050-1517-00

M41777

A21U565 AND A21U575 REPLACEMENT
(Firmware Version 2.0)

For TEKTRONIX® 468 Digital Storage Oscilloscopes

Fig. 2. A21 Microprocessor Circuit Board.

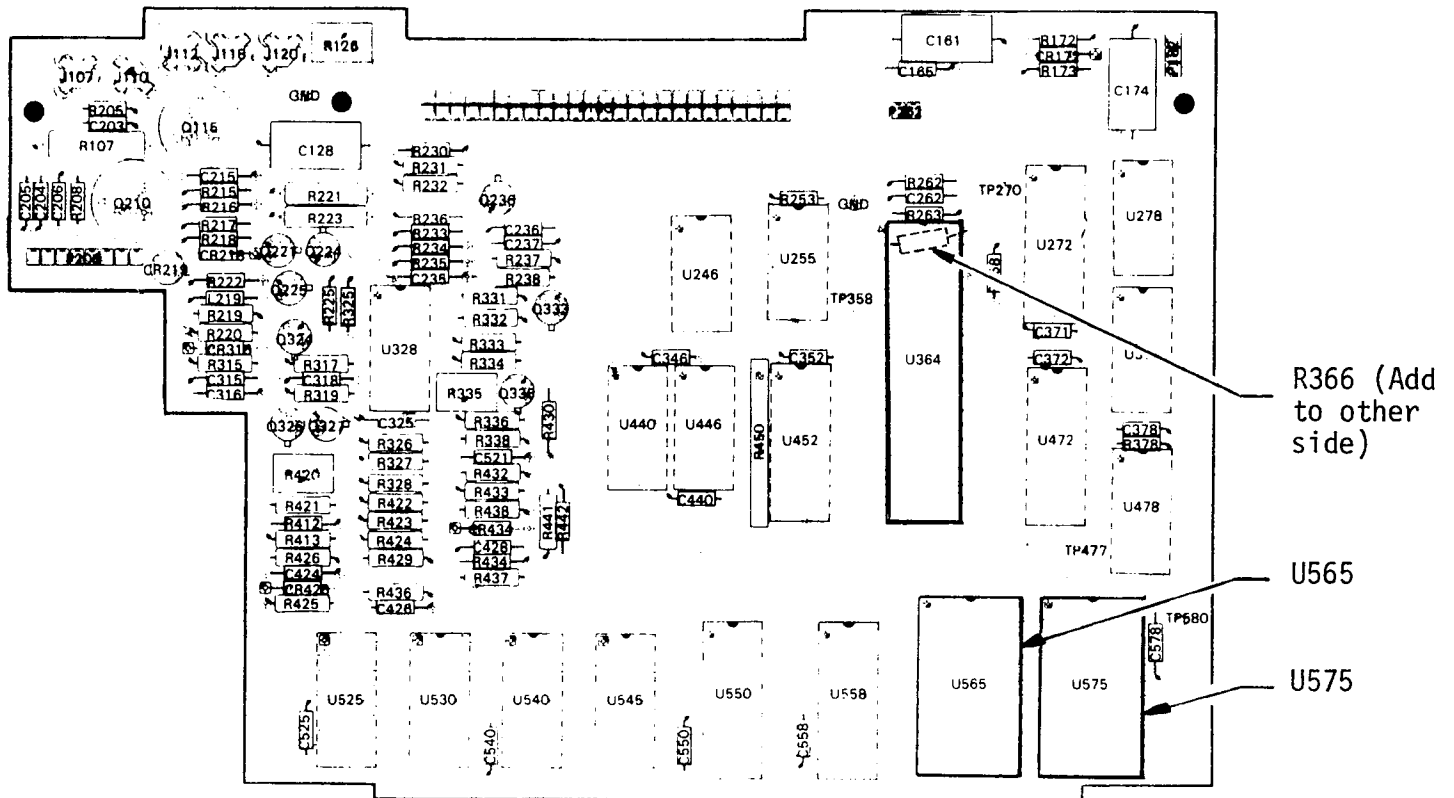
To eliminate several display anomalies, this modification kit replaces version 1.0 ROM's A21U565 (pn 160-0459-00) and A21U575 (pn 160-0759-00) with version 2.0 ROM's, pn 160-0459-01 and pn 160-0759-01, respectively.

To prevent random lockup of the readout display, A21R266 (510 Ω) must be added between pin 2 (X2) and pin 40 (+5V) of A21U364.

C. TO MODIFY THE MICROPROCESSOR CIRCUIT BOARD (See Fig. 2 for parts location):

- () 1. Replace U565 with the microcircuit marked "160-0459-01".
- () 2. Replace U575 with the microcircuit marked "160-0759-01".
- () 3. On the reverse side of the circuit board, solder R266, the 510 Ω resistor from the kit, between pins 2 and 40 of A21U364.
